From: Pederson Ronda M (AREVA NP INC) [Ronda.Pederson@areva.com]
Sent: Thursday, December 10, 2009 6:29 PM
To: Tesfaye, Getachew
Cc: BENNETT Kathy A (OFR) (AREVA NP INC); DELANO Karen V (AREVA NP INC); NOXON David B (AREVA NP INC); WILLIFORD Dennis C (AREVA NP INC)
Subject: Response to U.S. EPR Design Certification Application RAI No. 273, FSAR Ch 11, Supplement 4
Attachments: RAI 273 Supplement 4 Response US EPR DC.pdf

Subject: Response to U.S. EPR Design Certification Application RAI No. 273, FSAR Ch 11, Supplement 3

QUESTIONS for Health Physics Branch (CHPB)

Figure 11.05-4-1—Simplified Steam Generator Blowdown Flow Paths

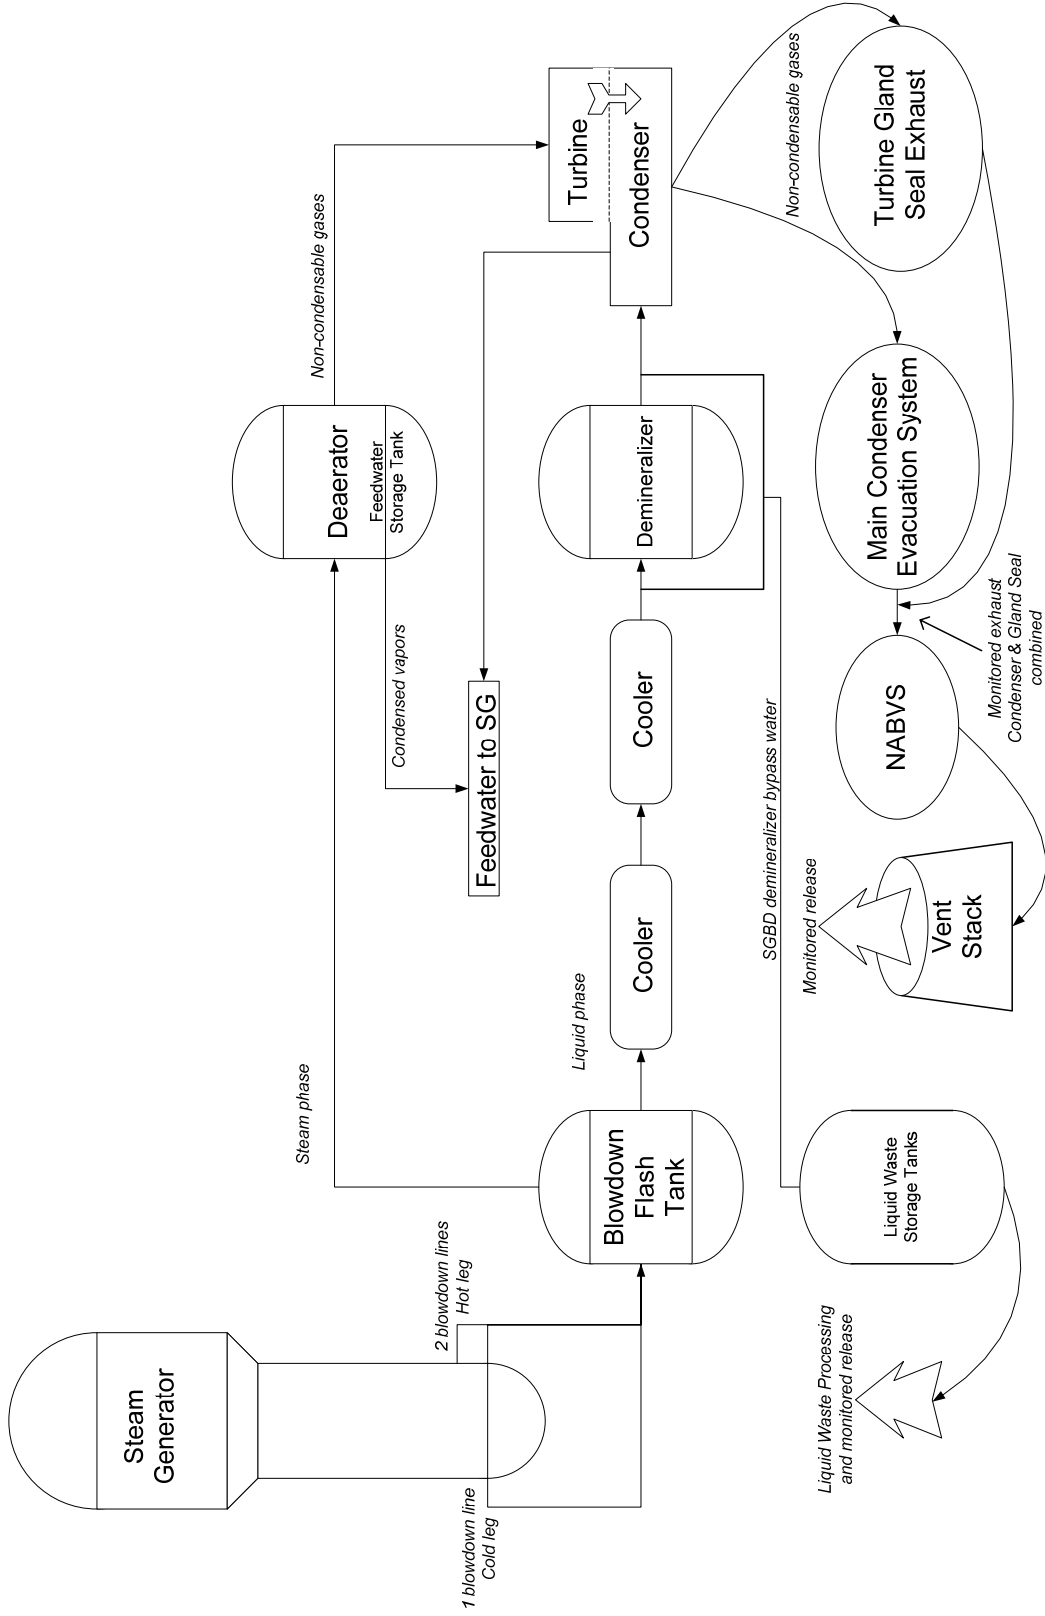
In Section 11.5.4.3, the FSAR describes the radiation monitoring system for the SG Blowdown. The discussion refers to releases occurring via TB roof ventilators in the event of SG tube ruptures. A review of FSAR Figure 11.5-1 indicates that this discharge path is not identified, as all gaseous effluent releases are shown to be discharged via the plant stack and FSAR Table 11.5-1 identifies this radiation monitor as a liquid effluent monitor and not as a gaseous effluent monitor. Accordingly, the applicant is requested to provide further information on whether releases from TB roof ventilators are unmonitored and uncontrolled release points to the environment. If the system design, as described in Section 11.5.4.3, allows the means to determine radionuclide distributions and concentrations during and after a SG tube rupture, describe methods and sources of radiological information with which to characterize such releases via TB roof ventilators and assess offsite doses to members of the public.

SGB fluids are extracted from the secondary loop, impurities are removed, and the fluids are returned to the secondary loop (See Figure 11.05-4-1). Each SG has three blowdown lines, two from the hot leg and one from the cold leg. The SGB is extracted from the hot side and cold side of the tubesheet in various combinations (See U.S. EPR FSAR Tier 2, Figure 10.4.8-1 (Sheet 1)). All three lines are combined into one common blowdown header. This common line is routed to the flash tank where the blowdown fluid is separated into a liquid phase and a steam phase (See U.S. EPR FSAR Tier 2, Section 10.4.8.2 and Figure 10.4.8-1(Sheet 2)). The liquid phase is cooled and polished (See U.S. EPR FSAR Tier 2, Figure 10.4.8-2 (Sheet 2)), then routed back into the secondary system via the main condenser and is not normally discharged through any effluent pathway. An abnormal, manually-initiated bypass to the liquid waste storage tanks provides a means to collect SGB demineralizer water. This liquid would be processed and discharged through the liquid effluent release pathway. The steam phase is routed to the deaerator/feedwater storage tank where the condensed steam is fed back into feedwater and is not discharged through any effluent pathway. Non-condensable gases stripped from the steam in the deaerator are routed to the steam side of the turbine, where the gases are exhausted through the main condenser evacuation system, a monitored pathway.

U.S. EPR FSAR Tier 2, Section 11.5.4.3 will be revised as described in the response and the FSAR markups provided by March 31, 2010.

Figure 11.05-5-1—Simplified Sketch of SBVS Exhaust Trains

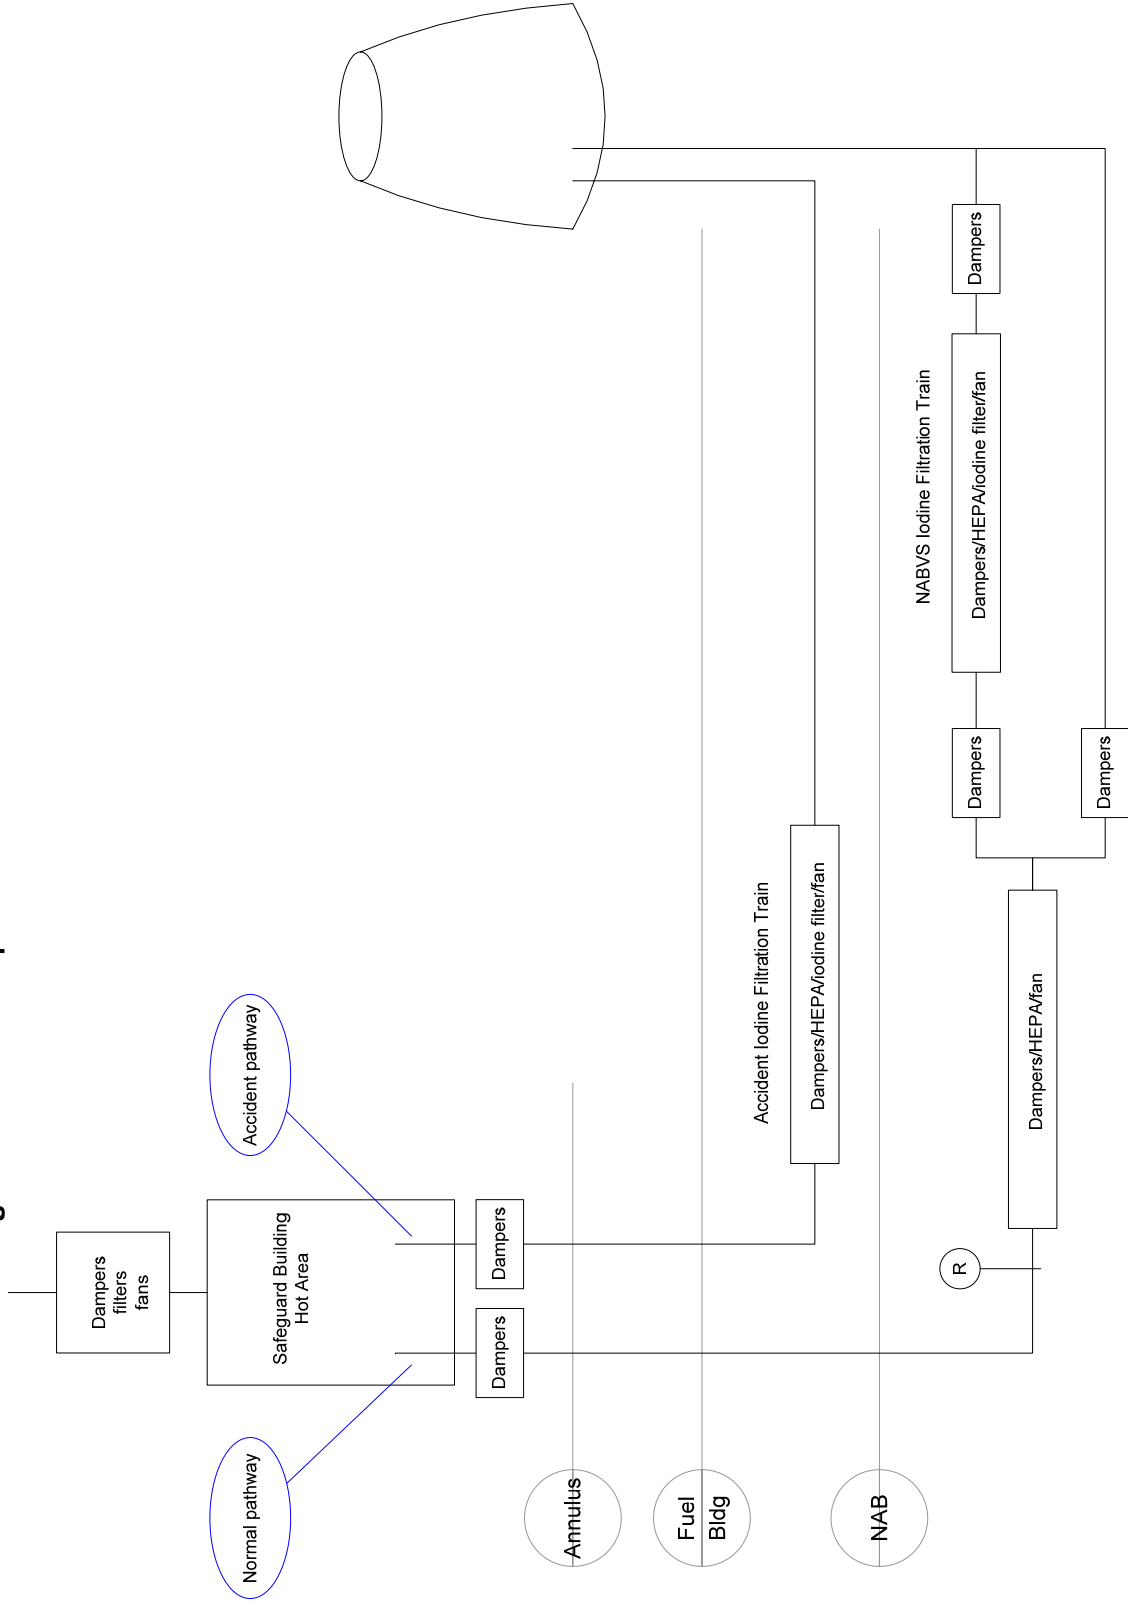
- 8) Figure 9.4.3-3 does not include a radiation detector in the Reactor Building Exhaust (last input on lower left side of drawing).
- 9) FSAR Table 11.5-1 implies that there are two continuous noble gas monitors for the containment building ventilation purge subsystem, but FSAR Figure 9.4.7-2 shows one monitor on the low flow purge exhaust and none for the full flow purge exhaust.

13) The SBVS has two separate exhaust trains, normal and accident, as shown in Figure 11.05-5-1. During normal operation, exhaust is directed down the normal pathway through the annulus, through the Fuel Building (FB), and into the NAB where it is labeled as "safeguard building hot area exhaust" on U.S. EPR FSAR Tier 2, Figure 9.4.3-3. At this point, the safeguard building exhaust enters the NABVS. This air flow is directed through a normal set of filters and discharged through the stack. On a high activity alarm from the radiation detector, flow is diverted within the normal pathway to the NABVS iodine filtration train shown on U.S. EPR FSAR Tier 2, Figure 9.4.3-4. However, on a containment isolation signal (e.g, triggered by a high radiation alarm on the in-containment high-radiation detector), the entire SBVS exhaust is diverted from the normal pathway to the accident pathway shown on Figure 11.05-5-1. SBVS exhaust is directed through the accident iodine filtration train in the FB and then discharged through the vent stack as shown on U.S. EPR FSAR Tier 2, Figure 9.4.5-2. For further information, refer to the Response to Question 11.05-8.

U.S. EPR FSAR Tier 2, Table 11.5-1 will be revised to indicate the automatic control feature that diverts flow to the NABVS iodine filtration train along with two footnotes. The first footnote will address that this is a non-safety-related automatic control feature. The second

Figure 9.4.5-2—Safeguard Buildings Exhaust Air Subsystem

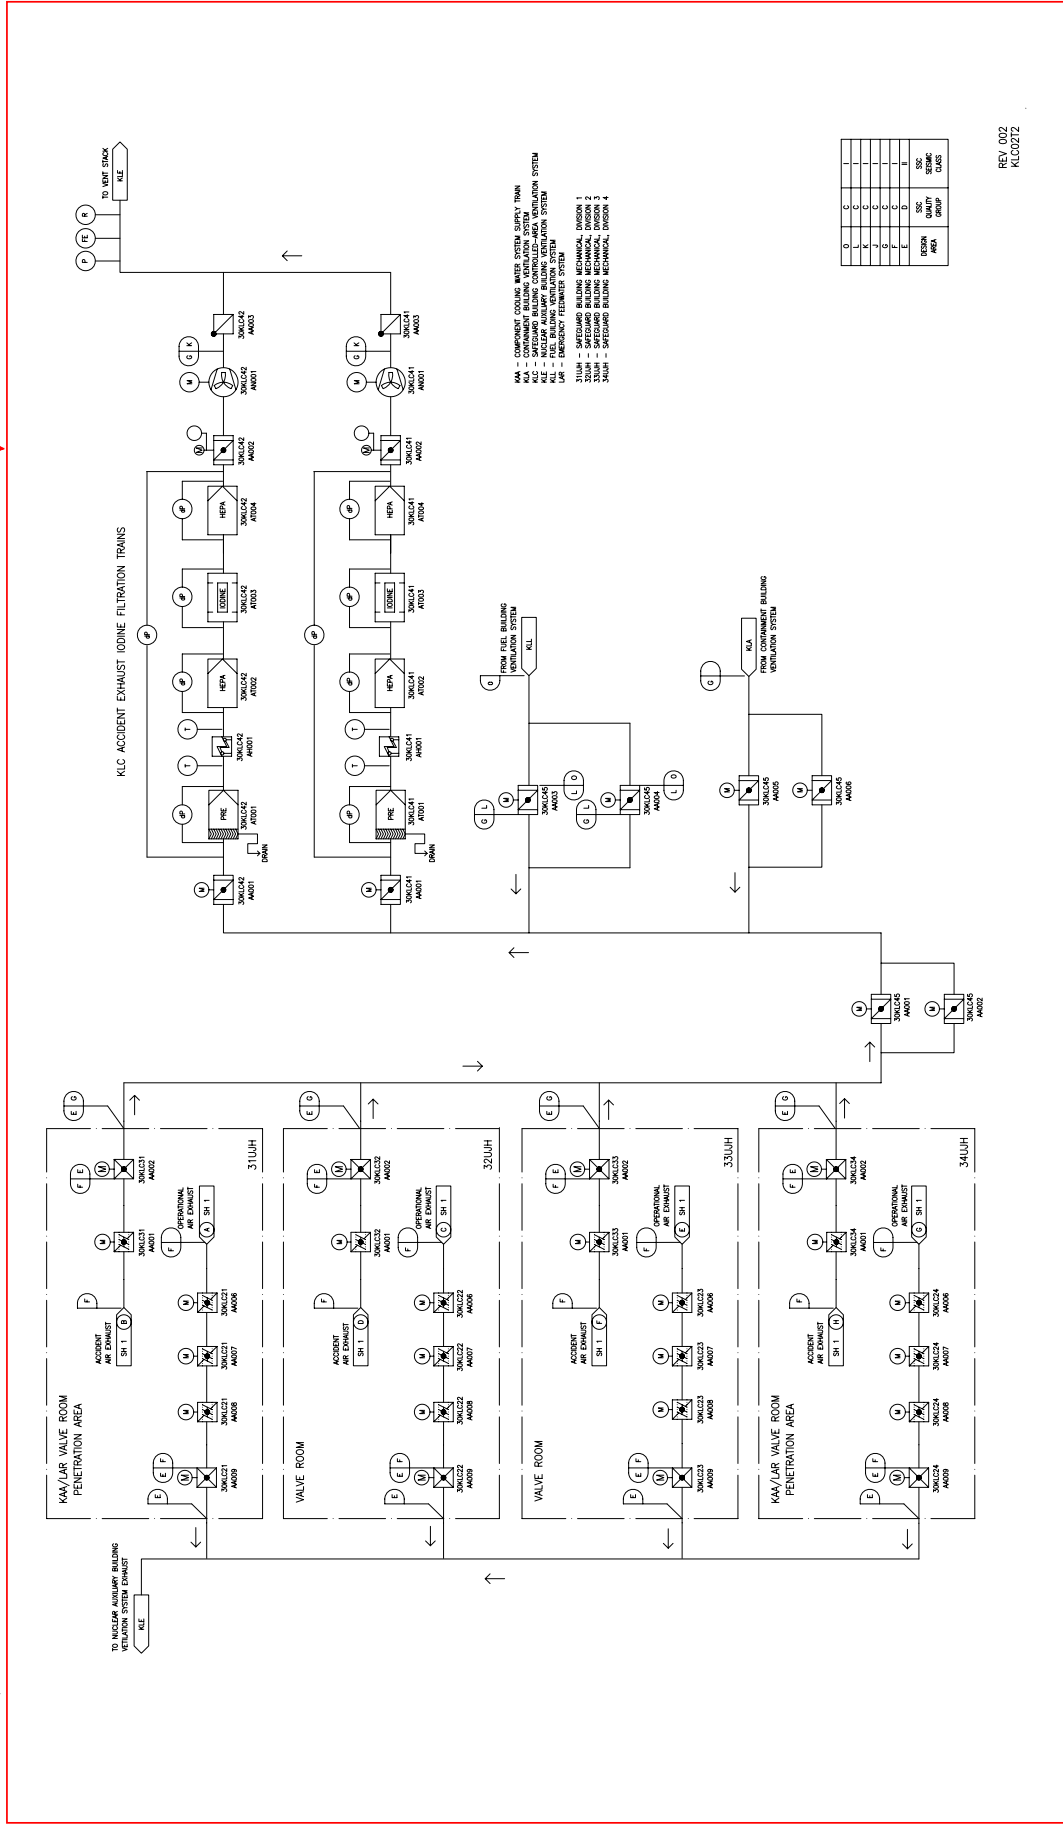
- b. Although FSAR Table 11.5-1 identifies the use of a multi-function process radiation monitor, its location could not be readily determined in FSAR Figure 9.4.5-2. Accordingly, Figure 9.4.5-2 should be reviewed to confirm whether its location is indicated and, if not, it should be added to the figure to ensure a complete representation of the system.

U.S. EPR FSAR Tier 2, Figure 9.4.5-2 will be revised to label the KLC accident exhaust iodine filtration trains.

- b. The multi-function monitor that measures noble gas, aerosol, and iodine in the SBVS exhaust is not on U.S. EPR FSAR Tier 2, Figure 9.4.5-2. However, it is on U.S. EPR FSAR Tier 2, Figure 9.4.3-3 on the SB hot area exhaust (lower left, second from the bottom). Although this multi-function monitor measures the activity in the SBVS exhaust, it is located within the NABVS, and is therefore located in Figure 9.4.3-3. There are two noble gas monitors, in the same detector housing (shown as 1 circled R), on the exhaust of the accident iodine filtration trains on U.S. EPR FSAR Tier 2, Figure 9.4.5-2. These monitors are in the SBVS system.

- a. U.S. EPR FSAR Tier 2, Figure 9.4.5-2 will be revised as described in the response and indicated on the enclosed markup.
- b. U.S. EPR FSAR Tier 2, Table 11.5-1 will be revised as described in the response and the FSAR markups provided by March 31, 2010.
- c. U.S. EPR FSAR Tier 2, Section 9.4.5.5 will be revised as described in the response and indicated on the enclosed markup.
